UNITED STATES
NUCLEAR REGULATORY COMMISSION
REGION IV
1600 EAST LAMAR BLVD
ARLINGTON, TEXAS 76011-4511

SUBJECT: SAN ONOFRE NUCLEAR GENERATING STATION – NRC AUGMENTED
INSPECTION TEAM FOLLOW-UP REPORT 05000361/2012010 AND
05000362/2012010

Inspection Report 05000361/2012010 and
05000362/2012010

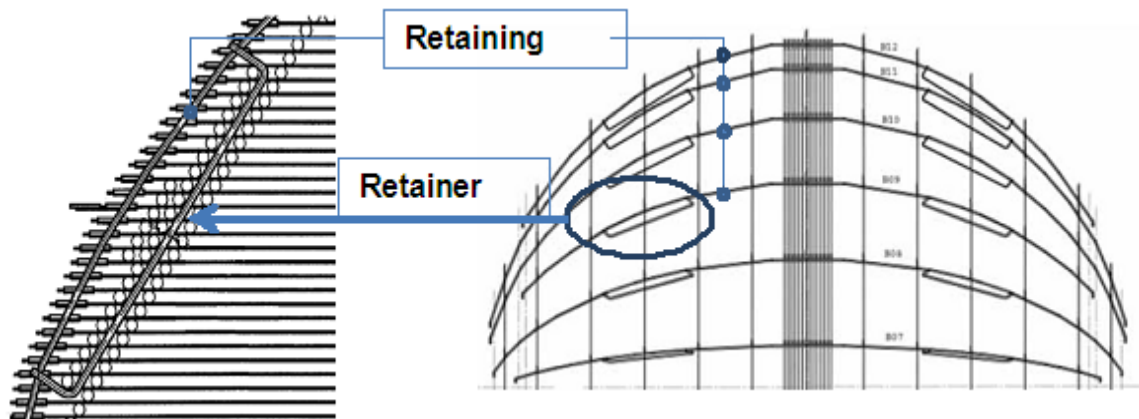
As shown in the figure below, the retainer bars are internal parts of the steam generator anti-vibration bar assembly that are attached to a series of retaining bars to capture a small group of tubes with the purpose of restraining movement of the anti-vibration bar assembly during manufacturing, upending during installation; and a main steam line break design basis event. The anti-vibration bar assembly was designed to float in between the tubes and be held in place by friction. There are 24 total retainer bars of two different diameter sizes in each steam generator. There are two groups of twelve bars where each group has six large and six small diameter bars. The different sized bars were needed to accommodate the different size of tube gaps in different areas of the bundle. Only tubes adjacent to the smaller diameter bars experienced wear indications. The retainer bars capture two short rows of tubes, which physically stop anti-vibration bar movement into or out of the tube bundle. Only those tubes immediately adjacent to both sides of the retainer bars (23 inside and 24 outside) were affected or potentially affected by vibration wear between the retainer bar and tubes. The first captured row was not affected by the retainer bar vibration.

The Cause Evaluation Report NN 201843216 identified that the mechanistic root cause of the tube-to-retainer-bar wear was due to inadequate design of the smaller diameter retainer bars in that the bar size (diameter and length) was insufficient to prevent excessive flow-induced vibration. The retainer bars were designed and fabricated with longer and smaller-diameter than previous designs, which resulted in a lower natural frequency when compared with previous configurations, increasing the susceptibility to flow-induced vibration. This resulted in tube wear from vibration contact between the retainer bars and tubes inside the steam generators. The vibration source was characterized as turbulent two-phase flow across the retainer bars.

Mitsubishi's technical evaluation Document SO23-617-1-M1562, Revision 4, stated that turbulence-induced vibration, buffeting, or random vibration were not considered in the design phase because generally the fluid force of this mechanism was small enough in the normal two-phase flow in the steam generator secondary side, and the natural frequency of the structure was high enough that structures were not expected to vibrate excessively. However, further evaluation of this mechanism found that this

was considered to be the most probable cause of the vibration in the smaller diameter retainer bars, based on flow forces near the retainer bars, combined with the rather low natural frequency of the retainer bar. The evaluation concluded that the cross-flow velocities in the replacement steam generators could result in large vibration amplitude of the smaller diameter retainer bars.
